UPPER UWCHLAN TOWNSHIP
BOARD OF SUPERVISORS WORKSHOP

August 13, 2024
4:00 p.m.

- I. Call to Order
 - A. Salute to the Flag
 - B. Moment of Silence
 - C. Inquire if any Attendee plans to audio or video record the Workshop
 - D. An Executive Session was held July 15, 2024 regarding a legal matter for a Conditional Use Decision and regarding personnel – Boards/Commissions candidates.
- II. Park & Recreation Board ~ Junior Member Appointment
- III. Village Concept Plan ~ Updated

CHESTER COUNTY, PA	
DECEMBER 4, 2023	
AS SHOWN	
Y:	---
:	MDC
ED:	VK
NG NO.	202317-1(C)
SHEET: 3 OF: 16

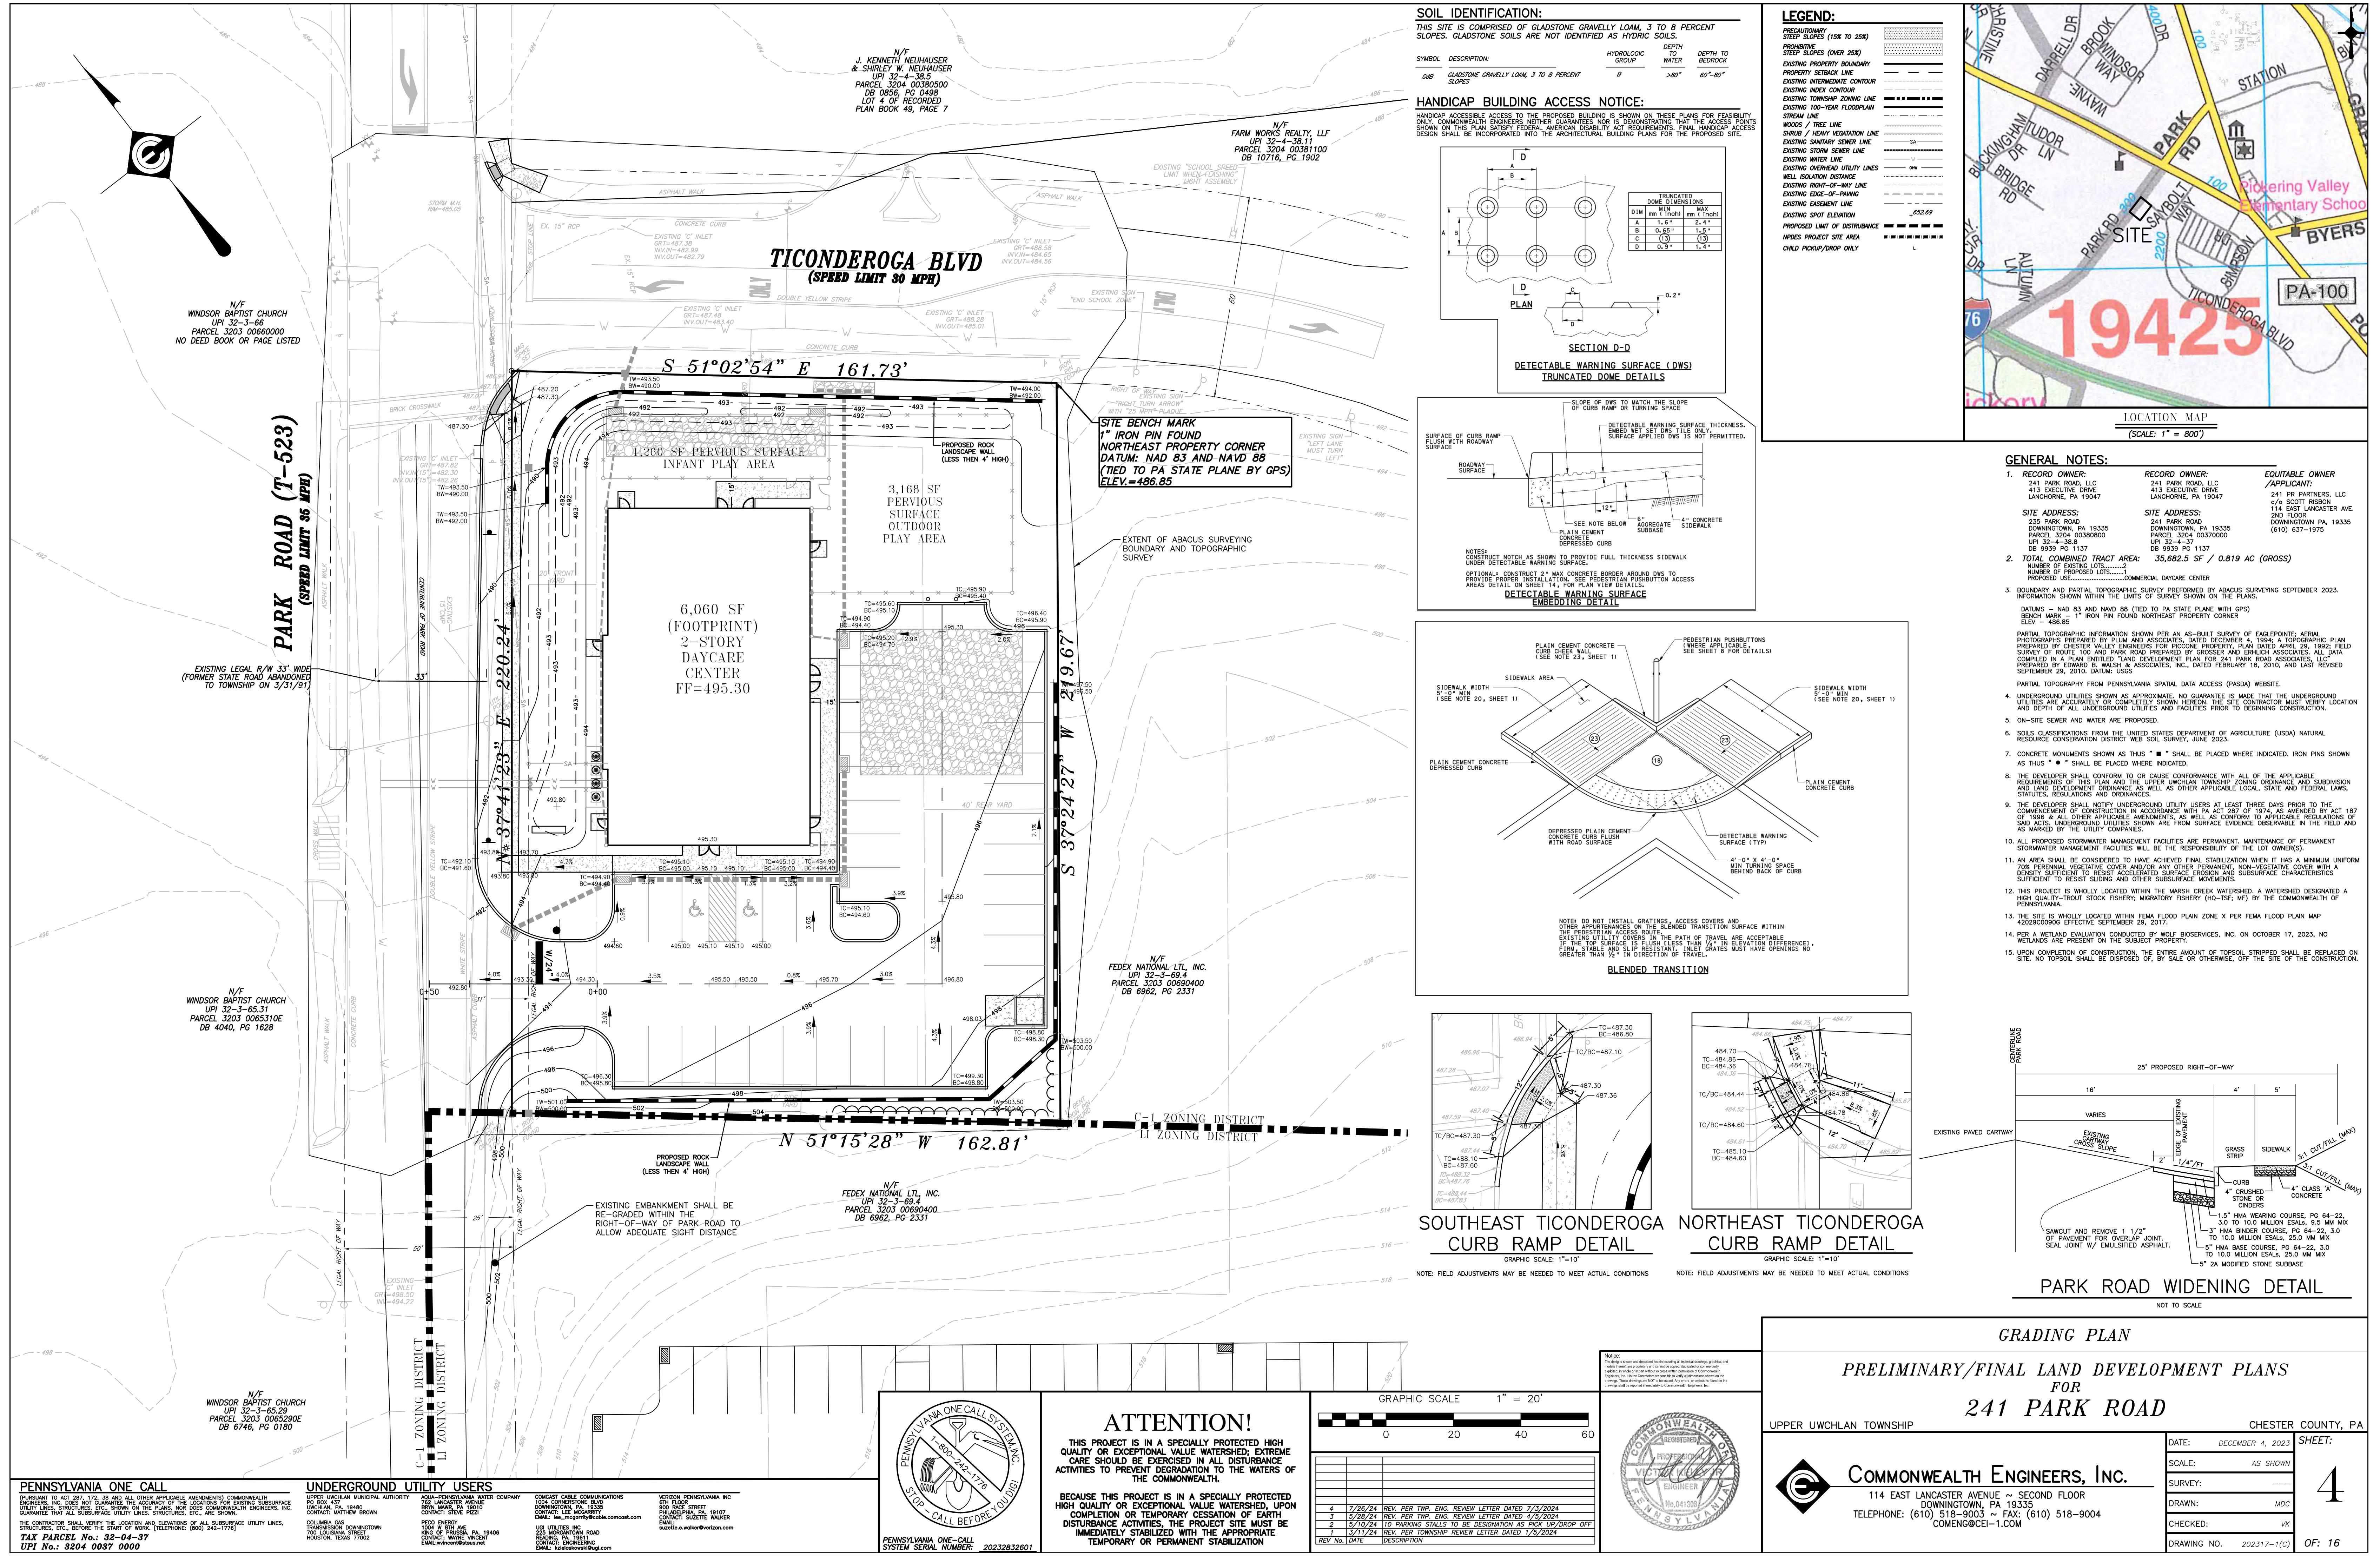
1. A detail for the rock landscape walls has been added to the plans. (See Sheet 8 of 16)
2. Existing features to be removed (TBR) should not be shown on any proposed conditions plans. Currently existing features TBR are shown on most proposed conditions plan sheets. *The existing signs shown in the entrance drive and in curbing (on Park Road) should be shown as to be relocated on the existing conditions plan and the relocated signs shown on all proposed plans.*

2. The existing sign to be relocated has been labeled on the Existing Conditions Plan and removed from any proposed conditions plans. (See Sheet 3 of 16)

4. All signs to be relocated have been labeled on the Existing Conditions Plan and removed from any proposed conditions plans. (See Sheet 3 of 16)
5. Remove the sight distance lines from all proposed conditions plans (except Sheet 14); remove the ISO candle values from the Landscaping Plan (Sheet 0); show the "Limit of Abacus Surveying Boundary" on the existing conditions plan only.
